UNITED STATES PATENT AND TRADEMARK OFFICE

APPLICATION NO.	FILING DATE	FIRST NAMED INVENTOR	ATTORNEY DOCKET NO.	CONFIRMATION NO.
10/604,504	07/25/2003	Clark C. Davis	1001.1869101	1503
28075 7590 07/06/2007 CROMPTON, SEAGER & TUFTE, LLC 1221 NICOLLET AVENUE SUITE 800 MINNEAPOLIS, MN 55403-2420			EXAMINER SZMAL, BRIAN SCOTT	
			ART UNIT 3736	PAPER NUMBER
			MAIL DATE 07/06/2007	DELIVERY MODE PAPER

Office Action Summary

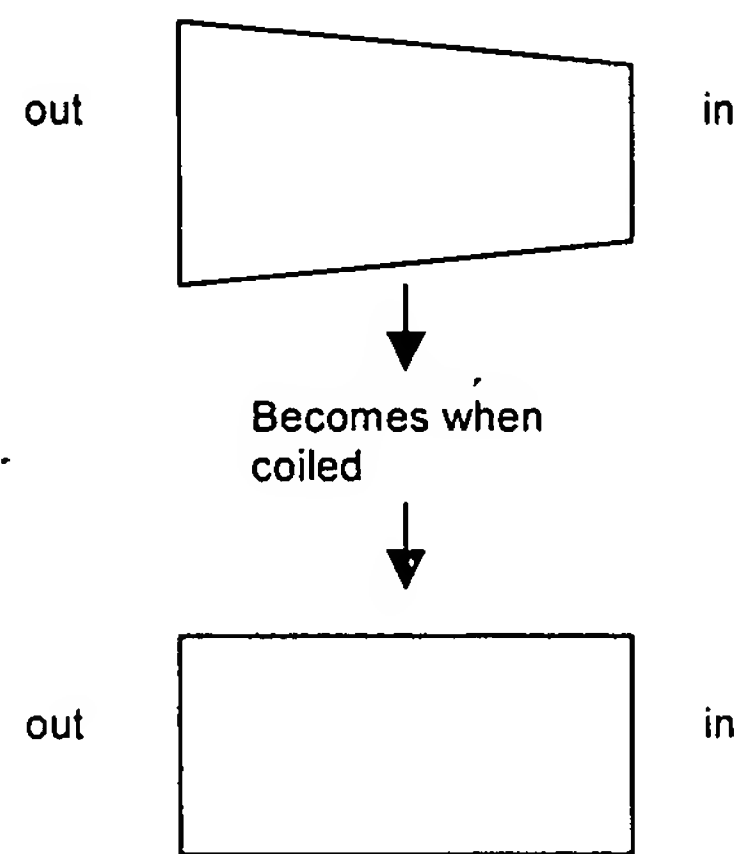
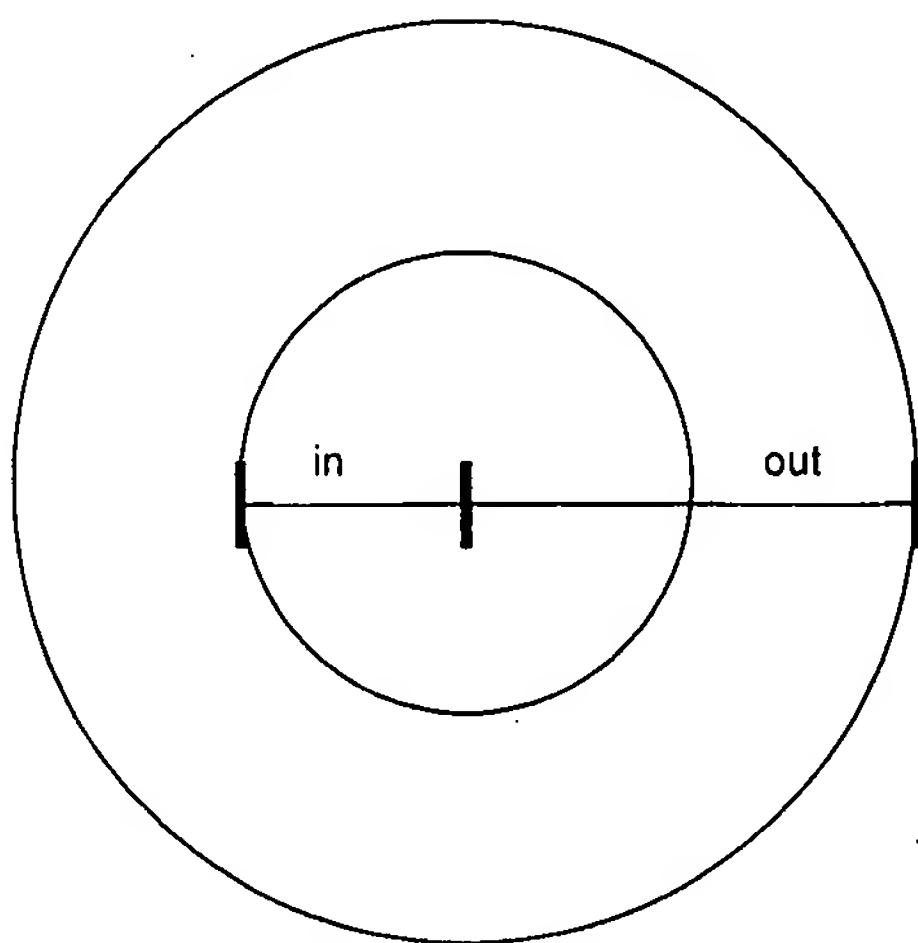
With regards to Claims 76-87, the Applicants further argue that Shiber fail to implicitly disclose the coil being created from a trapezoidal shape, wherein the trapezoidal shape becomes rectangular in shape when the coil is formed. The Examiner respectfully traverses the Applicants' argument. In order to form a coil that has a rectangular cross section, the flat stock that will form the wire must have a trapezoidal cross section prior to the material being formed into a coil. Otherwise, when the flat stock is formed into a coil, the axial diameter at the interior radius would have a thicker

diameter than that of the axial diameter at the outer radius. In other words, when flat stock is formed into a shape having a radius, the axial diameter of the flat stock at the inner radius will increase in size as the radius is decreased, creating a trapezoidal cross section from a rectangular flat stock.

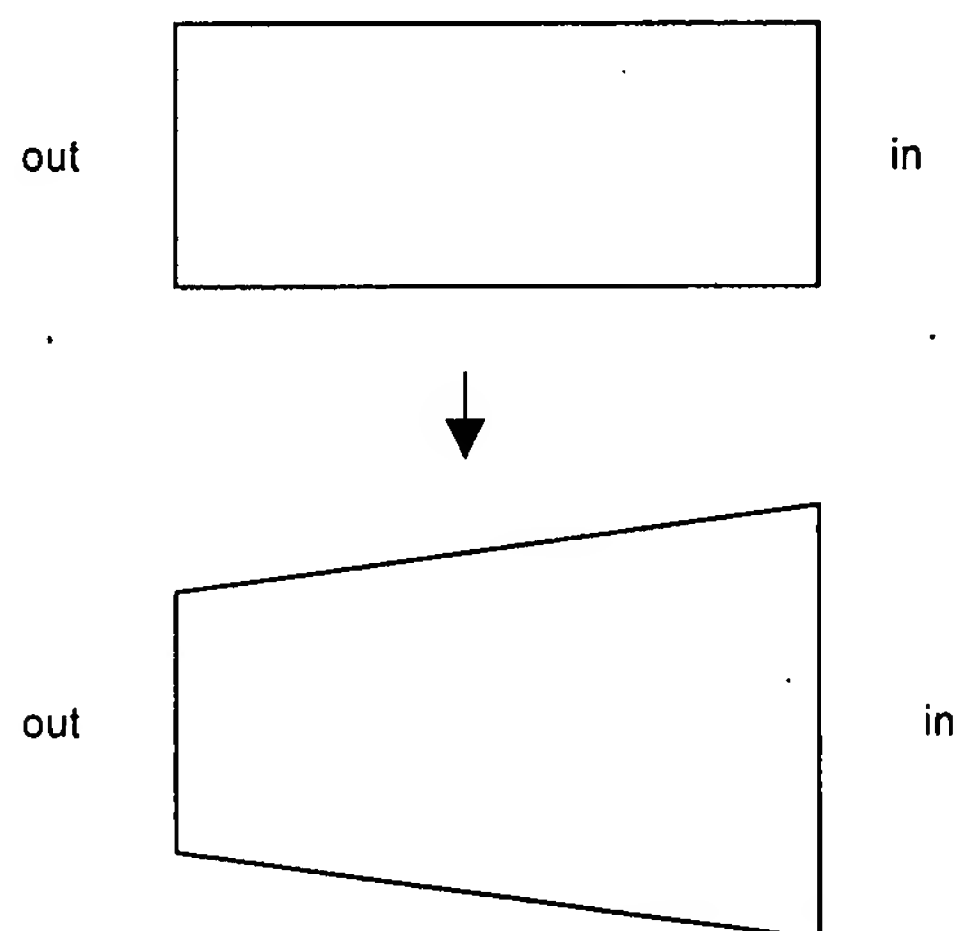
Otherwise, if the coil is formed from a rectangular flat stock, it would look like this:
